May 8, 2019

You requested a review of the Master Concept Plan for Estero Crossing for compliance with the Placemaking Elements of the Village's Comprehensive Plan. Per our discussion, I have finalized that review and plan, and am sending two copies of the Plan and a pdf of the plan and letter.

PLACEMAKING DIAGRAM

PLACEMAKING : START WITH ONE GREAT PLACE

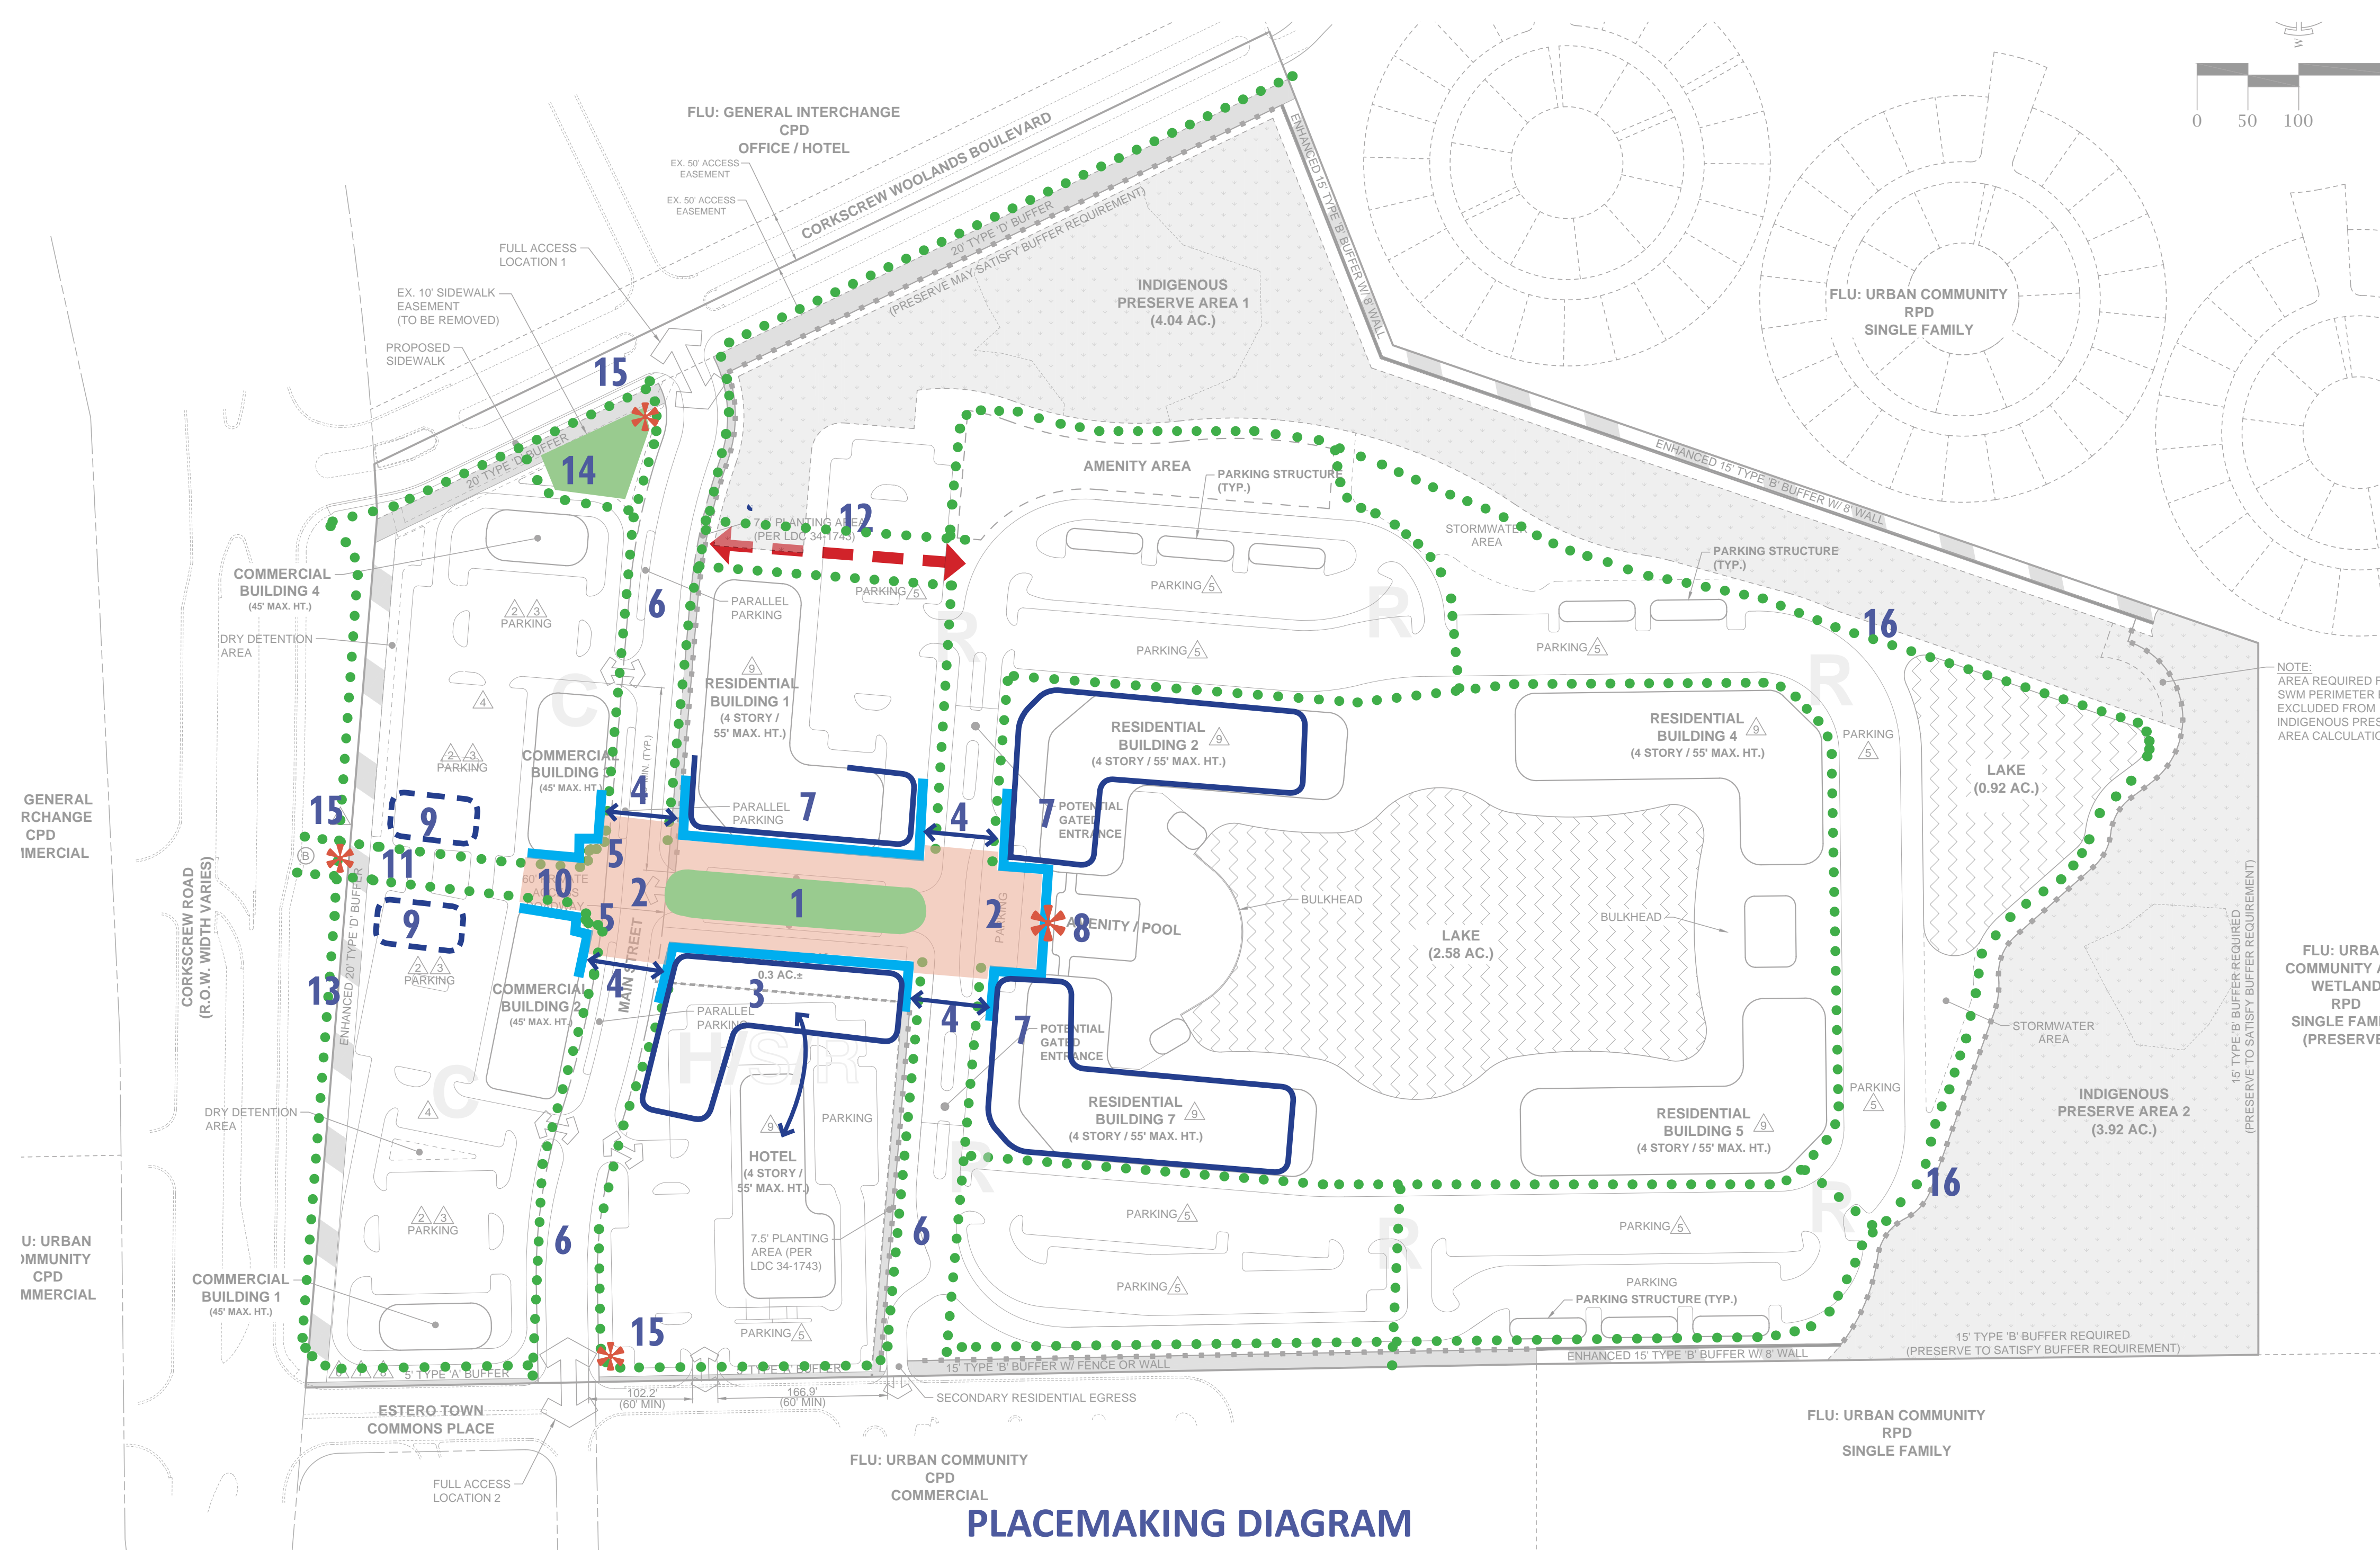
One comment may fall on the Village's side. The attached sidewalk along Corkscrew Road is not ideal along such a busy (and fast) thoroughfare. So, I proposed that a new sidewalk and/or a shared bike path be constructed that would be separated from the fast-moving traffic (ideally with a row of trees between). The other alternative would be to incorporate the sidewalk within the 20ft landscape buffer.

The subject property has been reviewed under the intent of the Comprehensive Plan, Future Land Use section 1.9.1. The project most closely follows the prescription for an *Integrated Horizontal Mixed Use* development. This paragraph states that components of the mixed use program should be placed so that "separate uses are perceived as unified live, work, play, and shop destinations." Further it says that "Placemaking design elements are spaces and infrastructure meant to function for public access, use, and interaction."

Using this approach, the reviewer recommends that the proposed buildings (commercial, residential, and hotel) be arranged to create **one great public space** that can function as a community gathering space. In this case a block-long urban green and plaza is proposed in place of the street that connects the Main Street to the residential amenity building. This is easily achieved by turning the proposed hotel approximately 90 degrees and aligning it with a proposed block-long street with a large center green-space that can be used for public functions. The public space must be defined by buildings that are situated close to the sidewalk (distance of 15-20 ft from the curb is generally recommended). The sidewalk should be wide with street trees and pedestrian-scaled lighting. The street around the perimeter can be one-way with parallel parking on the sidewalk side of the street.

Buildings along the perimeter of the public space should have "A-grade" facades (refer to diagram for extent) and active uses on the ground floor that may include commercial, residential, and hotel functions. A-grade facades refers to facades that are given special attention to detail, material, articulation, and with generous fenestration in the form of doors and windows (overly complex facades and roofs are not warranted). Multiple entries along the facade are encouraged. The facades at the ground level should have generous glazing in the form of windows and storefronts. Surface parking lots (other than street parking) should not be visible from the public space. Upper floors should have windows and, where desirable, balconies to foster interaction with the street.

Internal drives should be treated as part of the open space network and as **future streets**. The drives should have sidewalks, street trees and pedestrian-scaled lighting. This establishes the street and block network for future buildings.

Proposed alternates to hotel: The developer proposes two alternates to the proposed hotel: a storage building or a residential building. With either option, the urban form should match that of the hotel, that is, it should define the western edge of the proposed urban green-space. In the case of the storage building there should be some attempt to mitigate the negative impact of this "passive use" on the urban space. Therefore, it is recommended that active commercial uses (office, retail, etc.) be placed at the sidewalk level along the urban green with multiple entries along the sidewalk. The depth of the commercial uses can be shallow, but should not be less than 15ft. The upper floors of the storage building should have windows with a spacing similar to the residential buildings along the A-grade facades.

1. An **urban green** (20-40ft) is proposed. The green-space should be simply designed as a flat plane, with grass, pavers, and trees along the border. The space may be used as a quiet passive space, or be programmed at certain times to accommodate markets, music, etc.

2. **Traffic calming** achieved by using an alternative paving material for the public space to signify its importance and signal cars to slow down. The sidewalk can be raised or flush with the street and separated by planters and bollards.

3. Reposition Hotel/Residential/Storage building parallel to the proposed public space. At least one entry that connects to the building lobby should orient toward the public space.

4. Neck down the distance from building-to-building at the entrances to the public space to provide a greater sense of enclosure in the public space.
5. Wrap storefronts around corner of the commercial buildings to orient activity toward the public space. This is an ideal location for restaurants and cafes. The buildings can be notched to accommodate outdoor cafe seating.

6. Treat internal drives as future streets with street trees and sidewalks (min. 5ft).
7. Reposition residential buildings to define the street and create the urban open space.

8. Design the amenity building as an **identifiable landmark** of the plaza, give it vertical emphasis and "civic importance."
9. Recommended location of future commercial buildings to provide a gateway to the pedestrian zone. Alternatively, these could be open air structures, kiosks and other "lean" elements to help define the pedestrian connection.

10. Paseo- pedestrian connection between commercial frontage and urban greenspace.
11. Extend pedestrian paseo to Corkscrew Road. This would be an optimal location for a transit stop.

12. Consider an additional vehicular connection here. This would facilitate the closing of the urban greenspace for events like farmers markets, and concerts.

13. A detached sidewalk is recommended in place of, or in addition to, the existing sidewalk which is attached to the curb. This could be incorporated within, or adjacent to, the 20ft landscape buffer.

14. Proposed urban green with sidewalks on all edges. Could be used for outdoor seating.
15. Signage element that doubles as gateway element.
16. Proposed trail around the edge of the preserve. Ideally, this would be connected to trails on adjacent properties.
